UNITED STATES OF AMERICA
NUCLEAR REGULATORY COMMISSION

In the Matter of:)	
)	Docket No. 70-3103-ML
Louisiana Energy Services, L.P.)	
)	ASLBP No. 04-826-01-ML
(National Enrichment Facility))

**APPLICANT'S PREFILED TESTIMONY IN MANDATORY HEARING
CONCERNING MATTERS RELATED TO NUCLEAR CRITICALITY (SAFETY
MATTER NOS. 5 - 8 AND OCTOBER HEARING QUESTIONS 6.b, 6.e, 6.f, and 6.g)**

Figure 1 Mean Log Energy of Neutron Causing Fission versus H/U Ratio

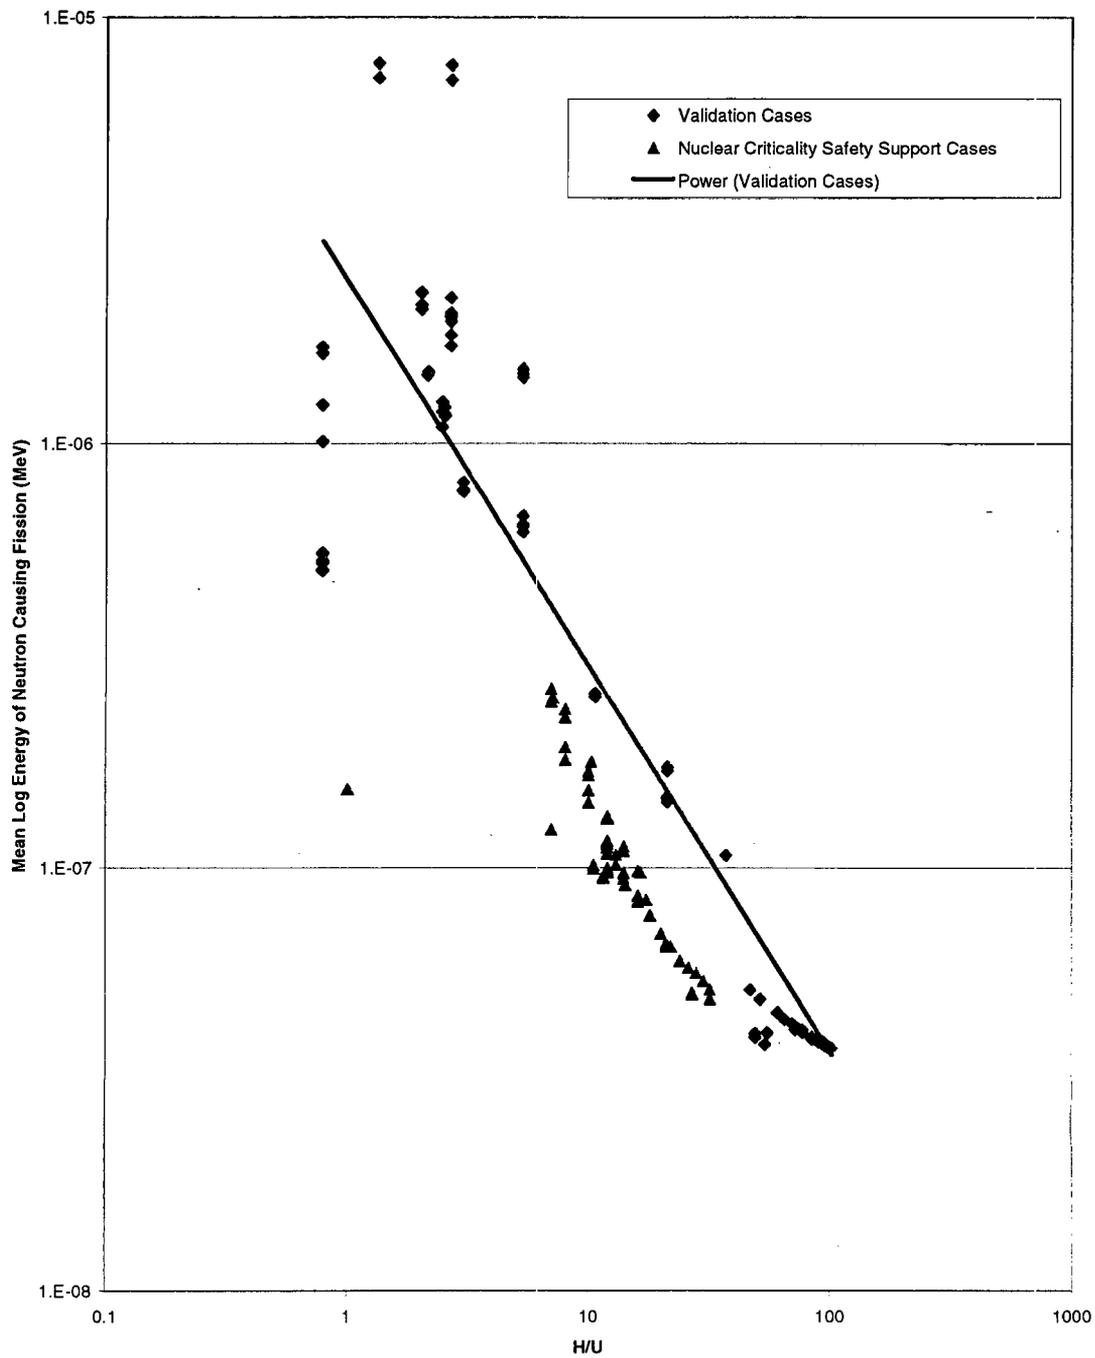
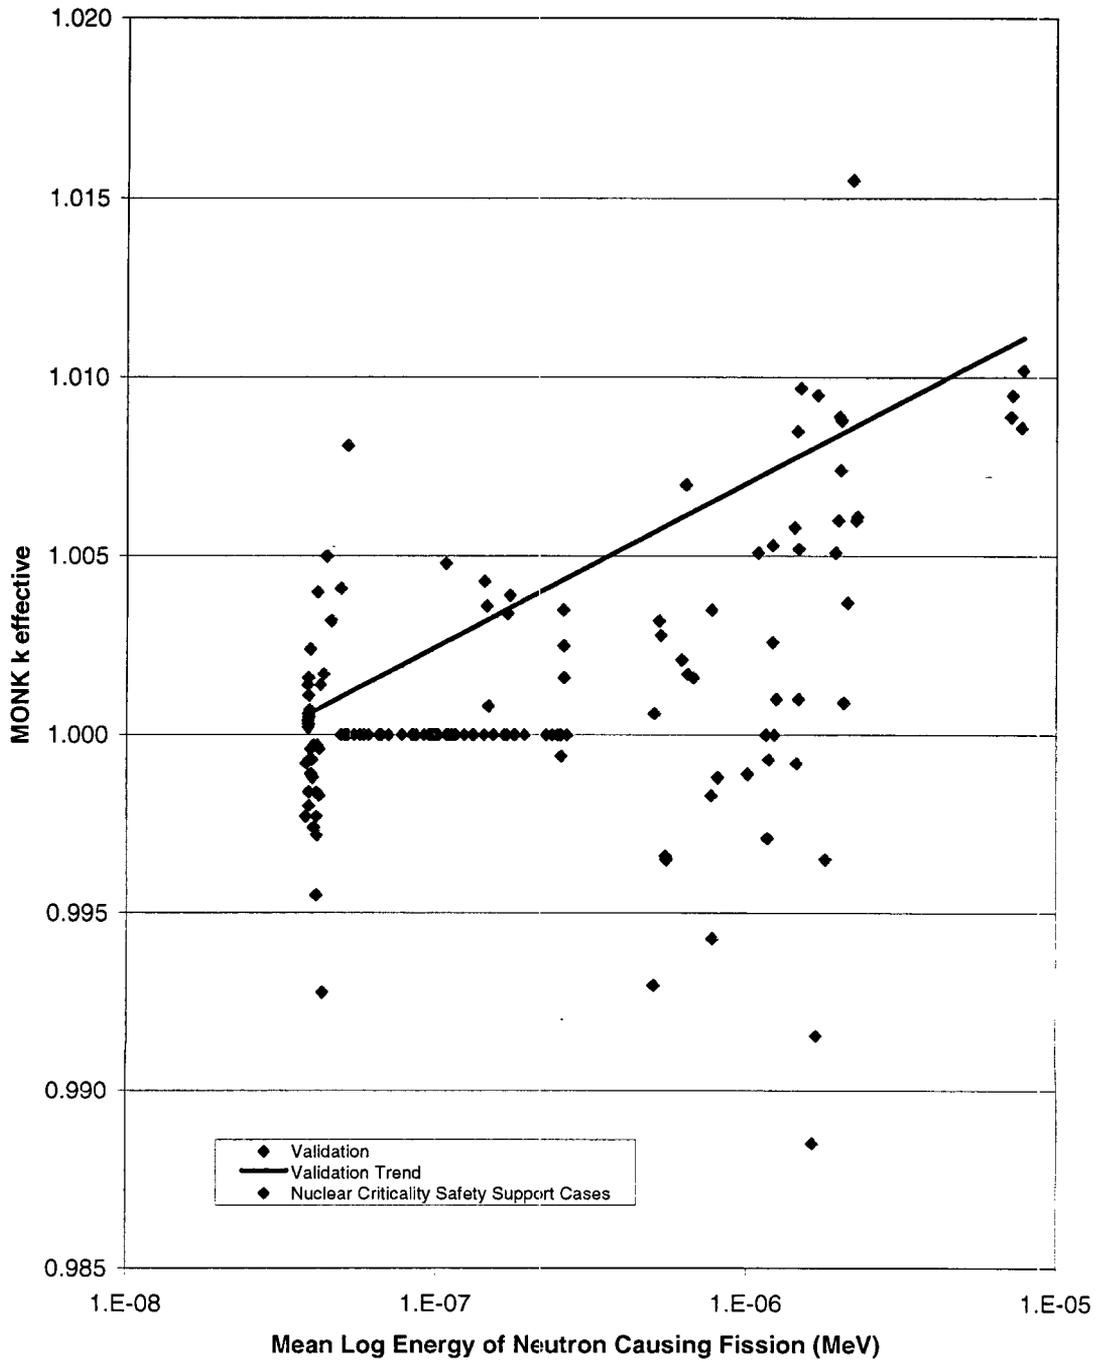
There are some gaps in the H/U ratios in the validation cases that may contribute to the calculated change in bias associated with variance of H/U ratio ranges. Given that the spectrum is primarily controlled by the H/U ratio, the impact of the variance of H/U ratio ranges

on the MONK 8A validation for NEF (*i.e.*, change in bias) can be answered by looking at how well the neutron energy spectrum is covered by the validation cases.

Figure 1 and Figure 2 ("Validation and NCS Support Analysis Cases k-effective vs Mean Log Energy of Neutrons Causing Fission") below show that the LMENCF for the NEF NCS support analyses cases cover a region of the plot that has some gaps in the validation cases. However, the NEF NCS support analyses cases all fall in an energy region below 1 eV. Neutron cross sections in this energy region vary very little with energy, and are usually well characterized by $1/v$ behavior. Given the well-behaved cross sections in this energy region, there is no reason to expect a change in bias due to a relatively small change in neutron spectrum. As a result, considering the strong correlation between H/U ratio and neutron energy spectrum, it is expected that the true impact (given sufficient applicable benchmark critical data) of the variance of H/U ratio ranges, for the ranges covered by the NEF NCS support calculation cases, should be insignificant.
